Product Change Notice (PCN)

PCN Number: **PCN-0454759R-01**

Product(s) Affected: SJ2-25414D-SMT-TR

PREVIOUS CUI DEVICES DETAIL / IMAGE	NEW CUI DEVICES DETAIL / IMAGE

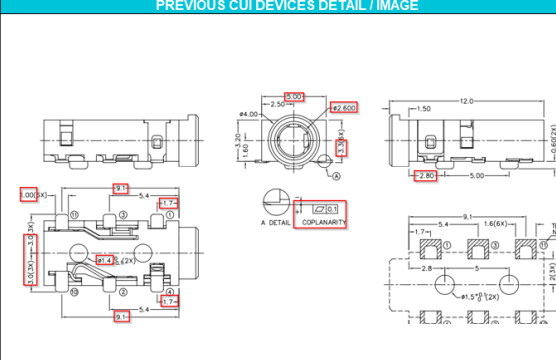
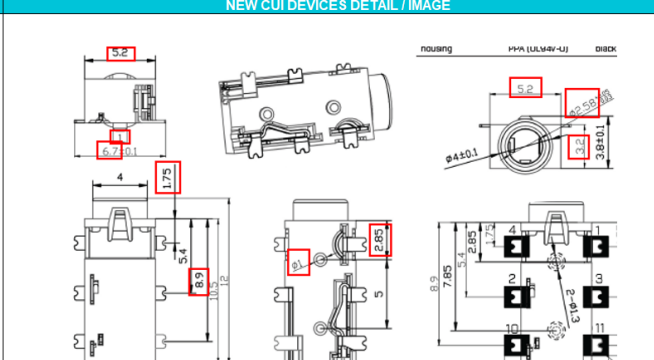
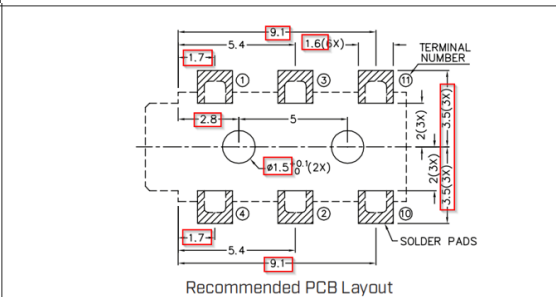
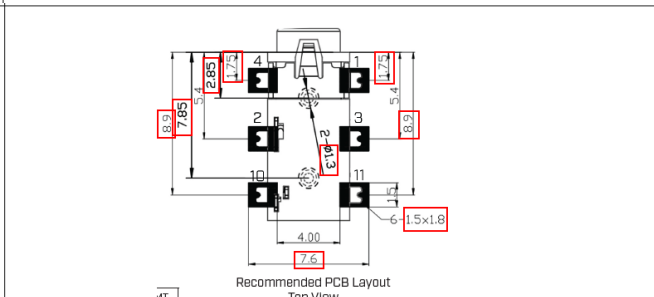
Description of Change: mechanical, material, packaging, and soldering differences as shown below:

<p>Recommended PCB Layout Top View</p>	 <p>Recommended PCB Layout Top View</p>																																																
<table> <tr> <th></th><th>MATERIAL</th><th>PLATING</th></tr> <tr> <td>terminal 1</td><td>copper alloy</td><td>gold flash</td></tr> <tr> <td>terminal 2</td><td>Ti-Cu</td><td>gold flash</td></tr> <tr> <td>terminal 3</td><td>copper alloy</td><td>gold flash</td></tr> <tr> <td>terminal 4</td><td>copper alloy</td><td>gold flash</td></tr> <tr> <td>terminal 10</td><td>brass</td><td>gold flash</td></tr> <tr> <td>terminal 11</td><td>brass</td><td>gold flash</td></tr> <tr> <td>plastic</td><td>PA10T</td><td></td></tr> </table>		MATERIAL	PLATING	terminal 1	copper alloy	gold flash	terminal 2	Ti-Cu	gold flash	terminal 3	copper alloy	gold flash	terminal 4	copper alloy	gold flash	terminal 10	brass	gold flash	terminal 11	brass	gold flash	plastic	PA10T		<table> <tr> <th>DESCRIPTION</th><th>MATERIAL</th><th>PLATING/COLOR</th></tr> <tr> <td>terminal 1</td><td>phosphorus bronze</td><td>gold</td></tr> <tr> <td>terminal 2</td><td>beryllium bronze</td><td>gold</td></tr> <tr> <td>terminal 3</td><td>beryllium bronze</td><td>gold</td></tr> <tr> <td>terminal 4</td><td>beryllium bronze</td><td>gold</td></tr> <tr> <td>terminal 10</td><td>phosphorus bronze</td><td>gold</td></tr> <tr> <td>terminal 11</td><td>phosphorus bronze</td><td>gold</td></tr> <tr> <td>housing</td><td>PPA (UL94V-0)</td><td>black</td></tr> </table>	DESCRIPTION	MATERIAL	PLATING/COLOR	terminal 1	phosphorus bronze	gold	terminal 2	beryllium bronze	gold	terminal 3	beryllium bronze	gold	terminal 4	beryllium bronze	gold	terminal 10	phosphorus bronze	gold	terminal 11	phosphorus bronze	gold	housing	PPA (UL94V-0)	black

MATERIAL	PLATING																																															
terminal 1	copper alloy	gold flash																																															
terminal 2	Ti-Cu	gold flash																																															
terminal 3	copper alloy	gold flash																																															
terminal 4	copper alloy	gold flash																																															
terminal 10	brass	gold flash																																															
terminal 11	brass	gold flash																																															
plastic	PA10T																																																
DESCRIPTION	MATERIAL	PLATING/COLOR																																															
terminal 1	phosphorus bronze	gold																																															
terminal 2	beryllium bronze	gold																																															
terminal 3	beryllium bronze	gold

terminal 4	beryllium bronze	gold																																															
terminal 10	phosphorus bronze	gold																																															
terminal 11	phosphorus bronze	gold																																															
housing	PPA (UL94V-0)	black
